Addendum No. 1

(CITY OF KINGSVILLE BID NO. 24-14)
2023-2024 CITY WIDE MISCELLANEOUS CONCRETE
AND DRAINAGE IMPROVEMENT PHASE III

**2023-2024 CITY-WIDE MISCELLANEOUS CONCRETE AND
 DRAINAGE IMPROVEMENTS - PHASE 3**

N. 2ND ST. FROM W. C AVE. TO W. B AVE.
 PLAN AND PROFILE - STA. 0+00 TO END

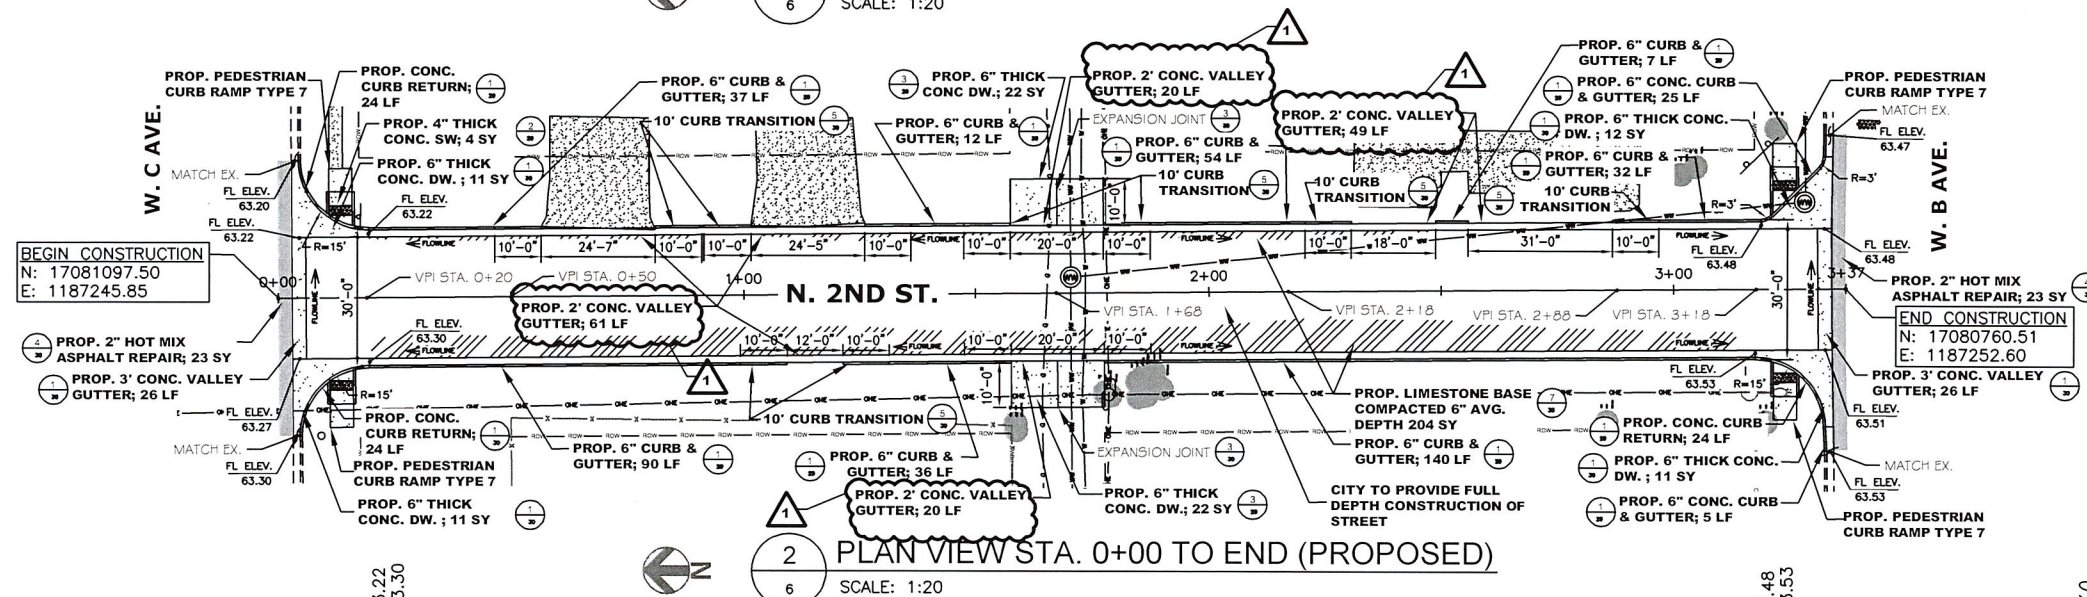
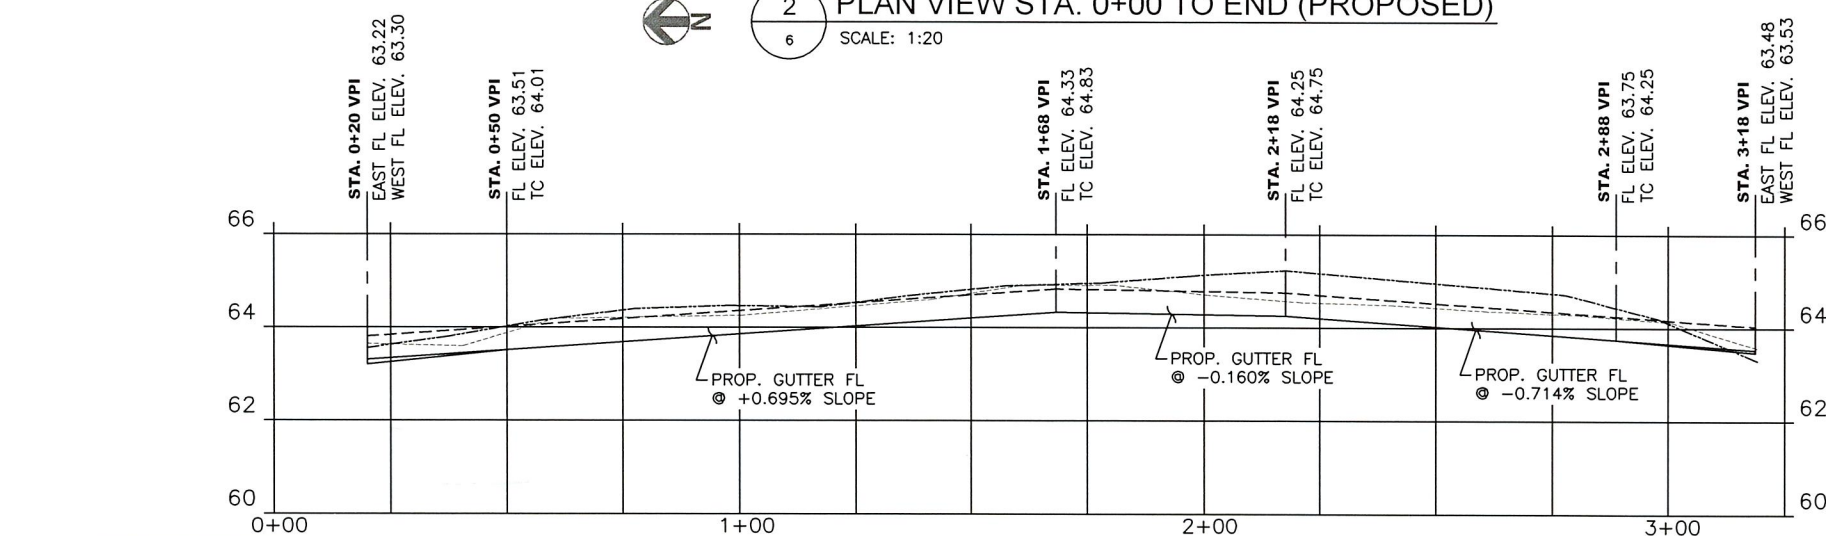
REVISED 7/24/2024
 1 2' CONC. VALLEY GUTTER
 NOTES & REVISED SHEET
 QUANTITIES.

WELLS ST. FROM W. I AVE. TO W. B AVE.
PLAN AND PROFILE VIEWS - STA. 0+00 TO END

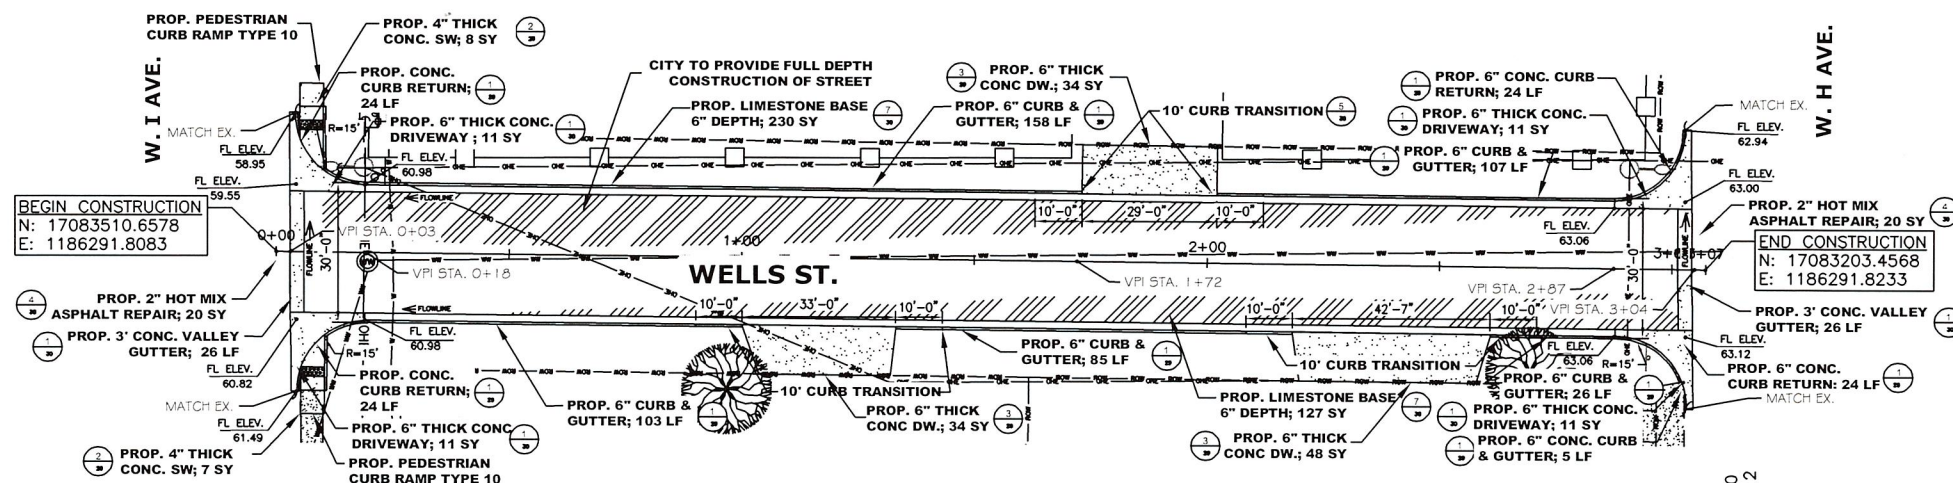
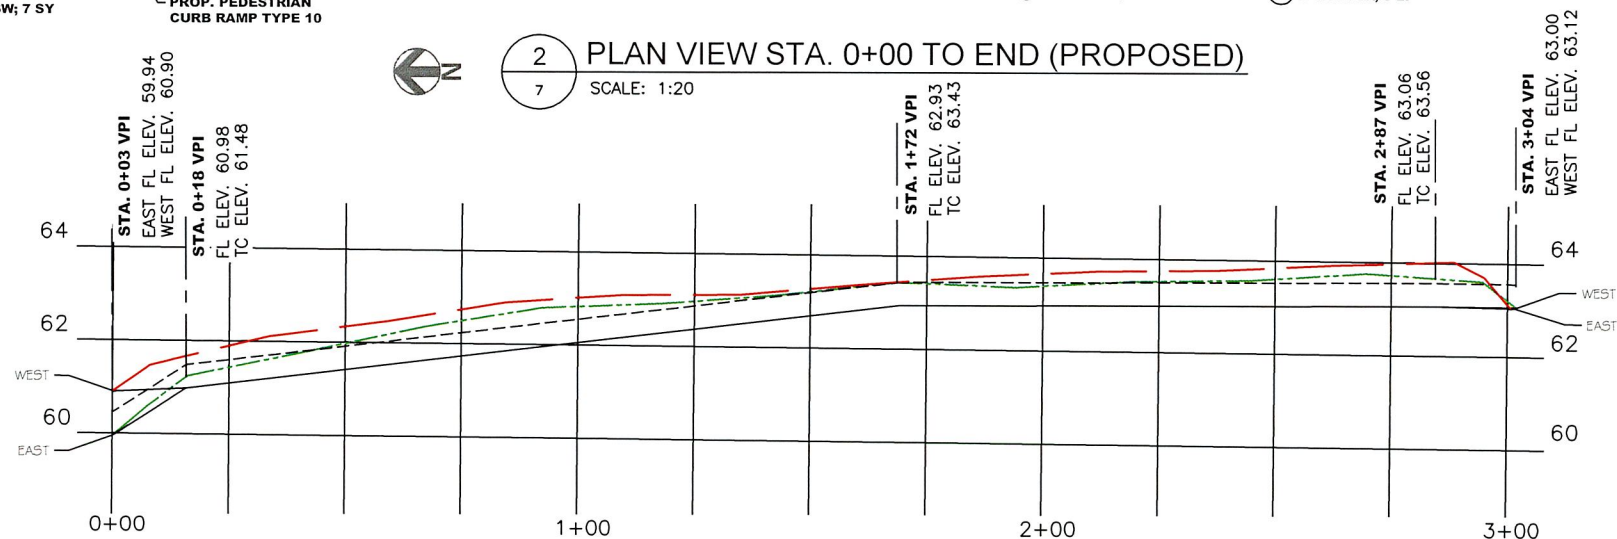
1 REVISED QUANTITY AND UNIT

2023-2024 CITY-WIDE MISCELLANEOUS CONCRETE AND
DRAINAGE IMPROVEMENTS - PHASE 3
DRAINAGE FLUME FROM E. LAWDALE DR. TO
E. SEN. CARLOS TRUAN BLVD. PLAN AND PROFILE - STA 0+00 TO 2+50

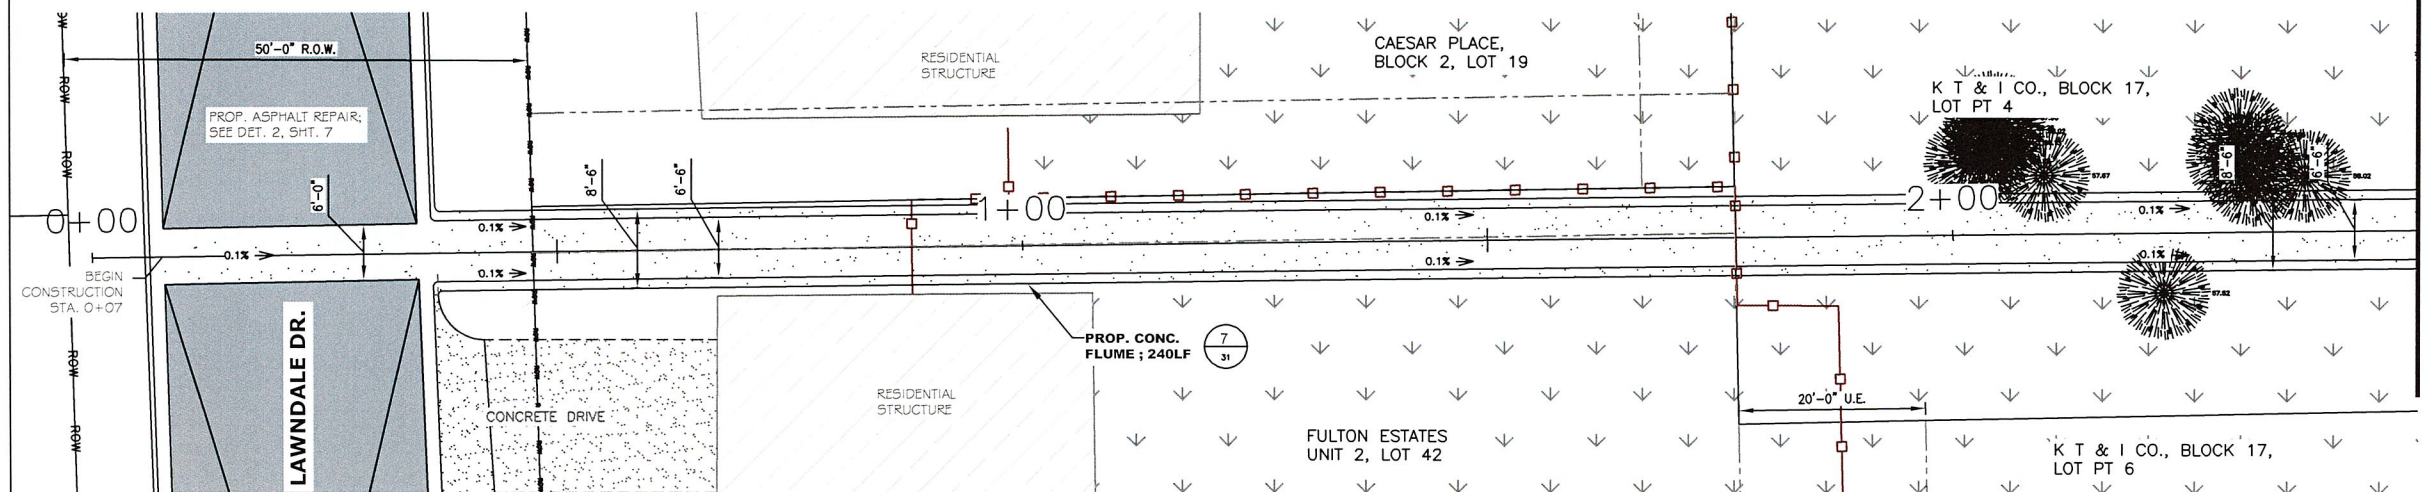
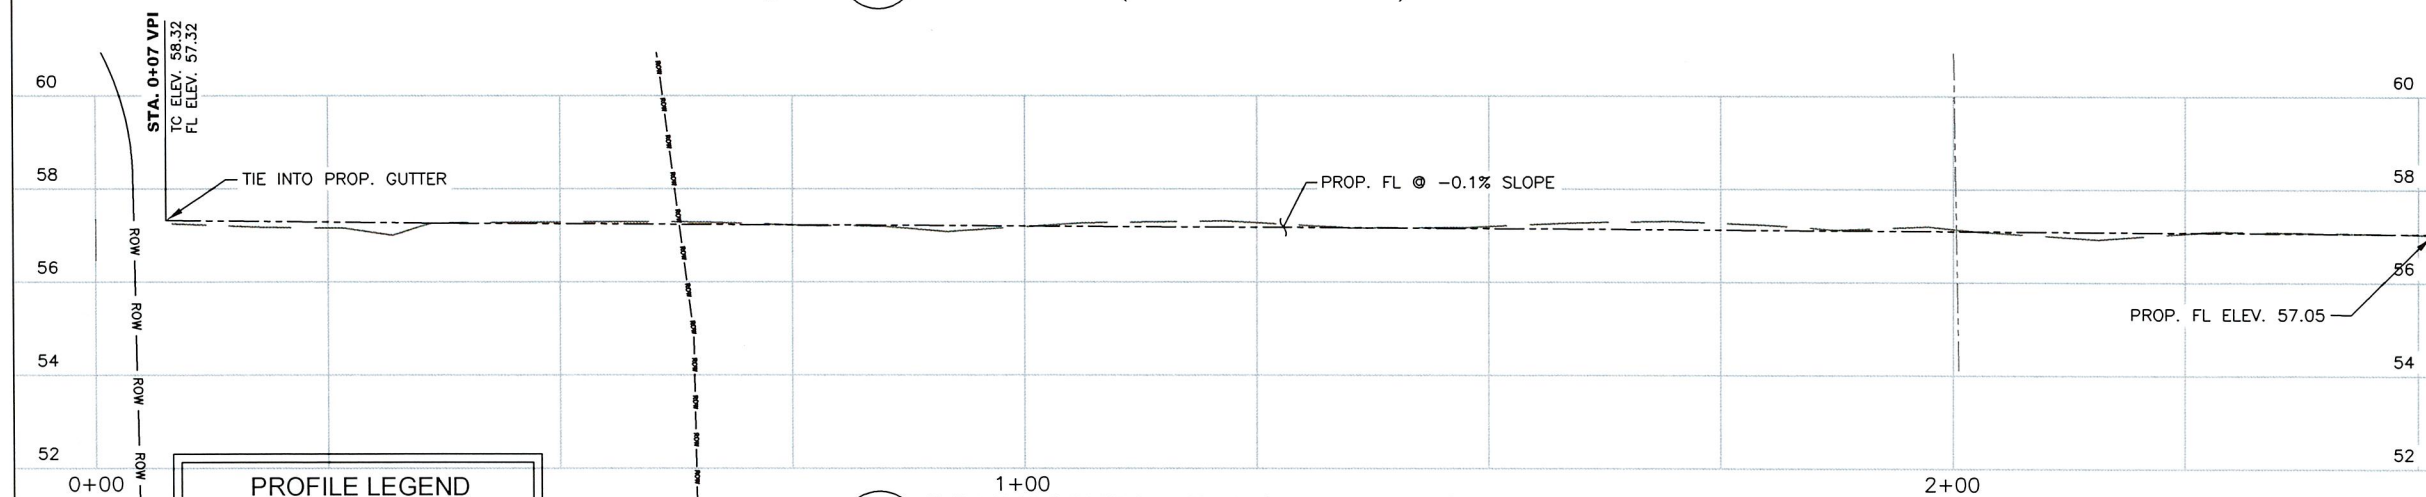
REVISED 7/24/2024
REMOVE VEGETATION ITEM
ADDED & REVISED SHEET
QUANTITIES.

DRAINAGE FLUME BETWEEN E. LAWDALE DR. TO
E. SEN. CARLOS TRUAN BLVD. PLAN AND PROFILE - STA 2+50 TO 5+00

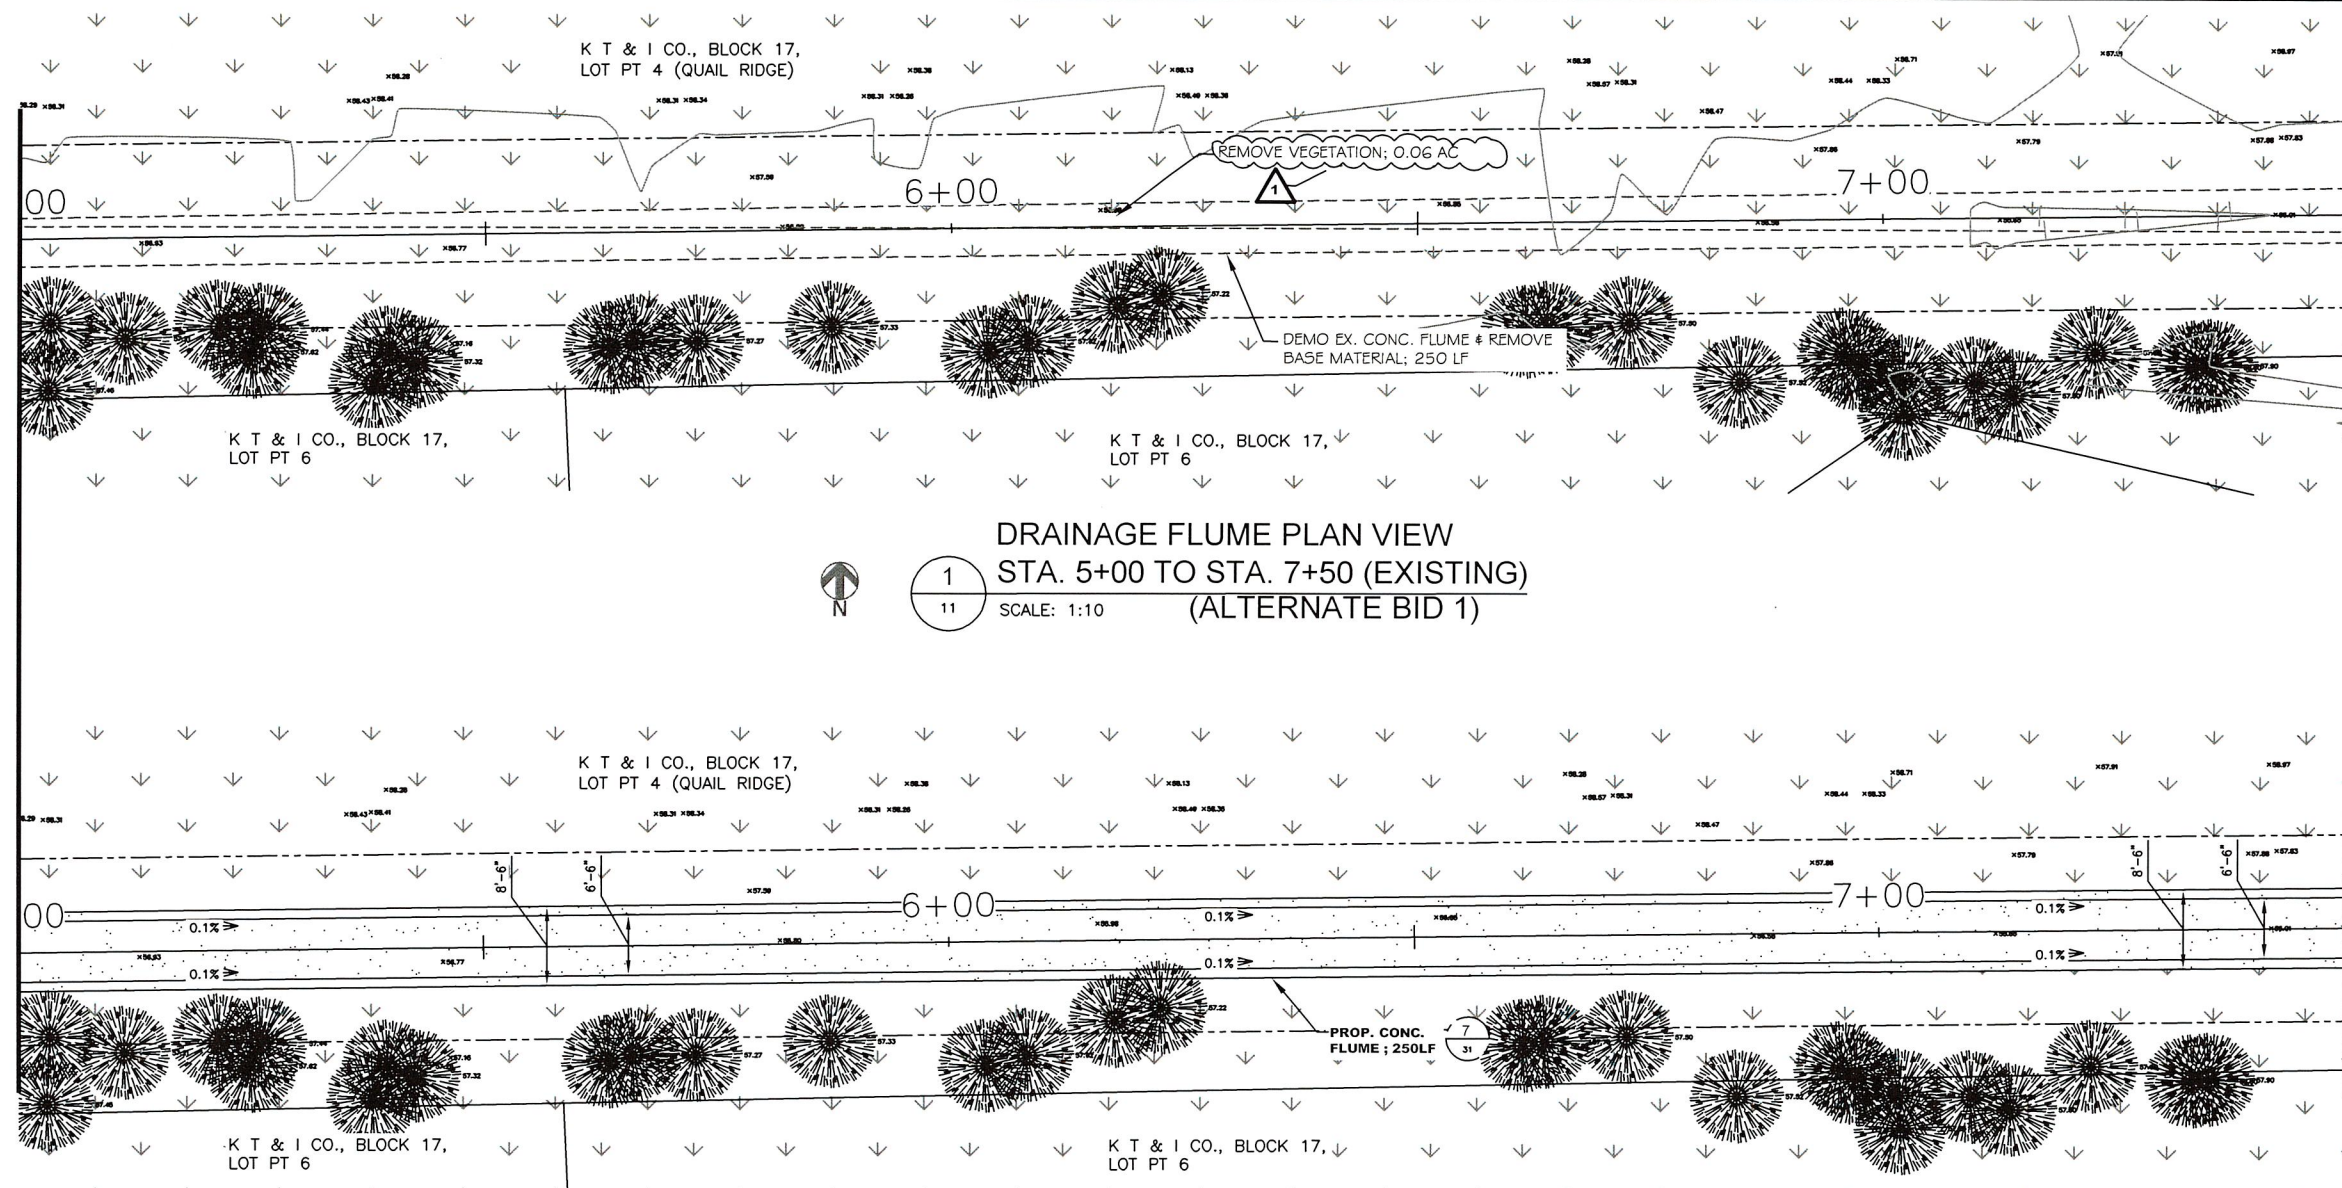
REMOVE VEGETATION ITEM
ADDED & REVISED SHEET
QUANTITIES.

DRAINAGE FLUME BETWEEN E. LAWDALE DR. TO
E. SEN. CARLOS TRUAN BLVD. PLAN AND PROFILE - STA 5+00 TO 7+50

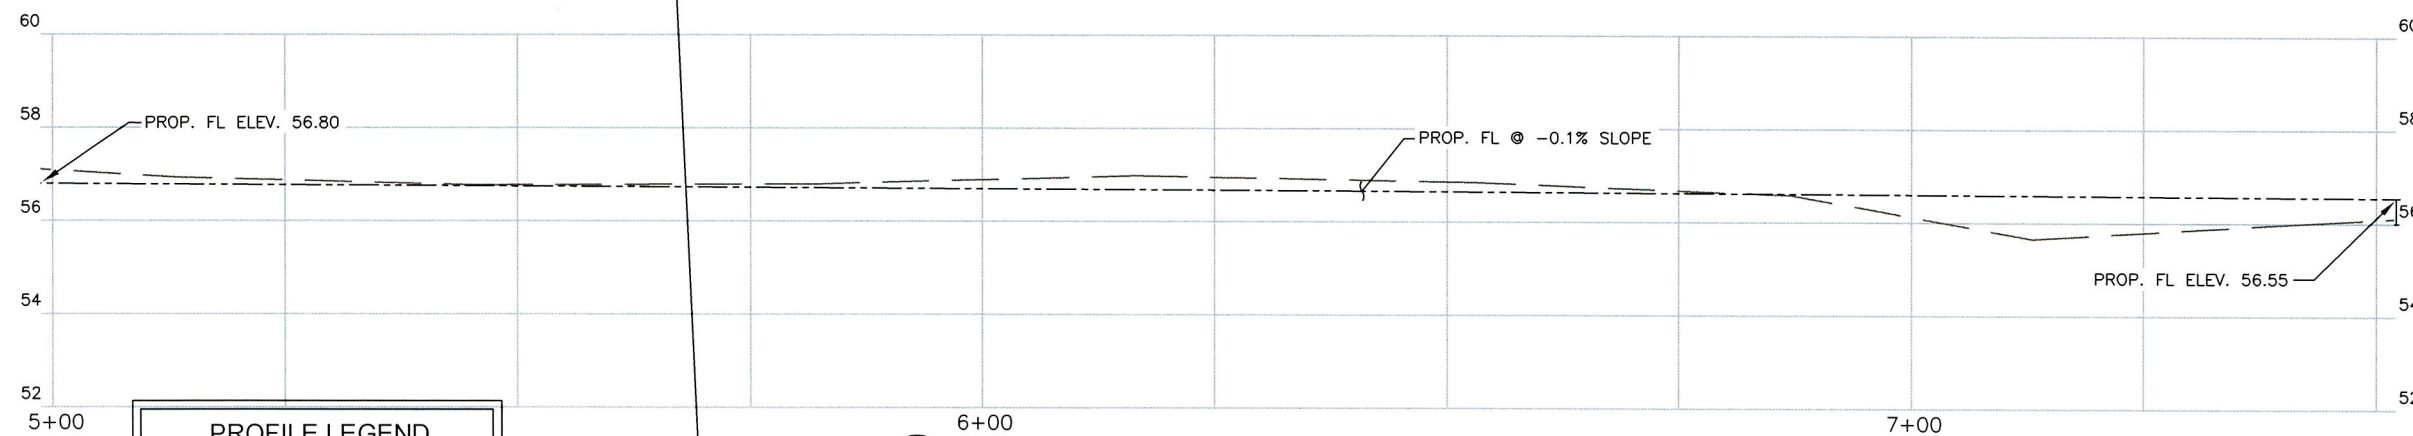
REVISED 7/24/2024
REMOVE VEGETATION ITEM
ADDED & REVISED SHEET
QUANTITIES.
